Subject: Work Plan for Conducting Subsurface Investigation at
Tony's Express Auto Services, 3609 International Boulevard
(formerly East 14th Street) Oakland, California – StID#3337

**WORK PLAN TO CONDUCT DATA COMPILATION,
EVALUATION OF SITE CLEAN UP OBJECTIVE AND
PREPARATION OF CORRECTIVE ACTION PLAN AT
TONY'S EXPRESS AUTO SERVICES
3609 INTERNATIONAL BOULEVARD
OAKLAND, CALIFORNIA**

PROJECT 99-2330

Figure 3: Proposed Groundwater Monitoring Well Locations (MW-12 & MW-13)

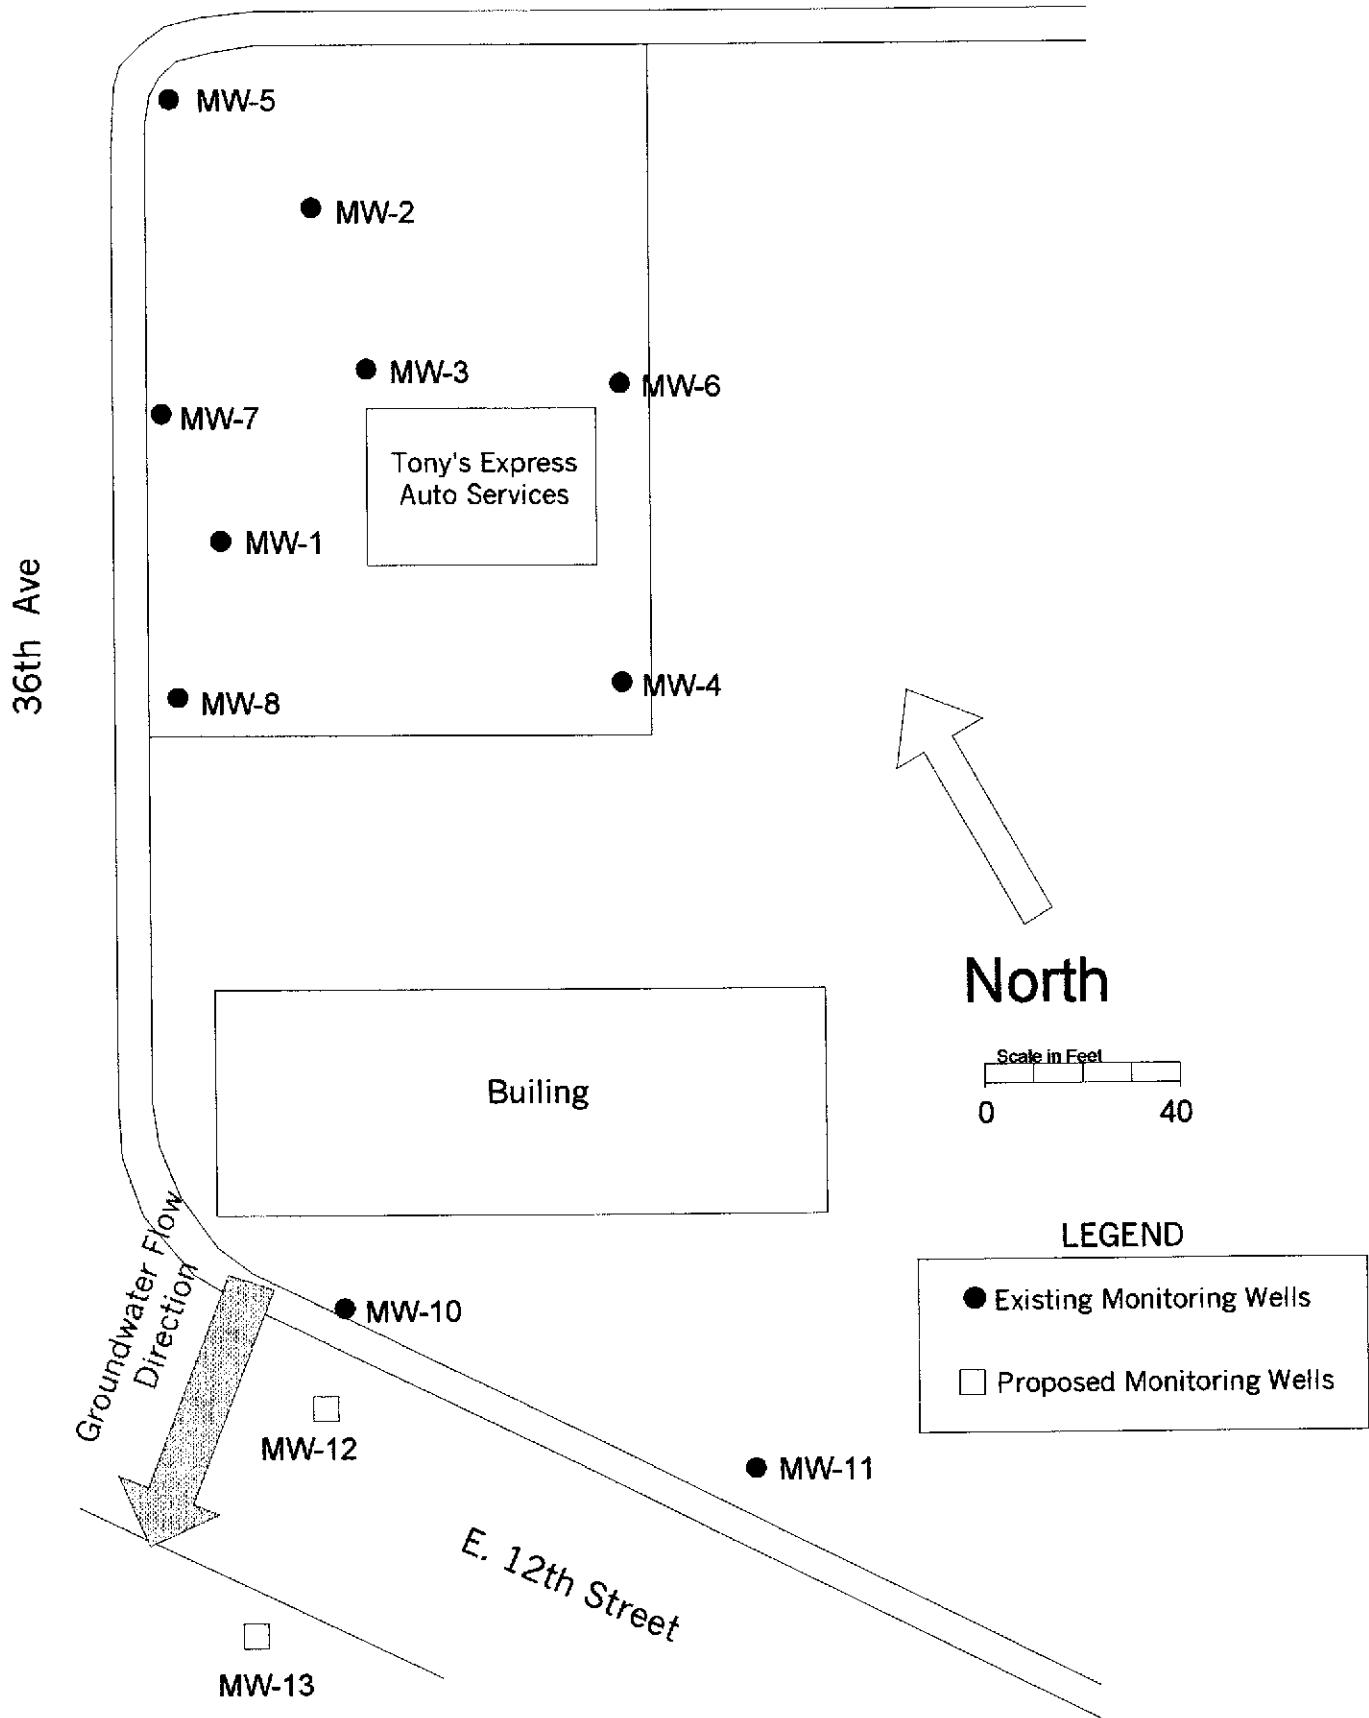
- probably could do w/ 1 gravel
+ 1 well instead of 2 wells
- exp / shrinking plane related to
pump tests?
- model results must be verified
by spring results.

*how about
1 temp &
1 permanent
well*
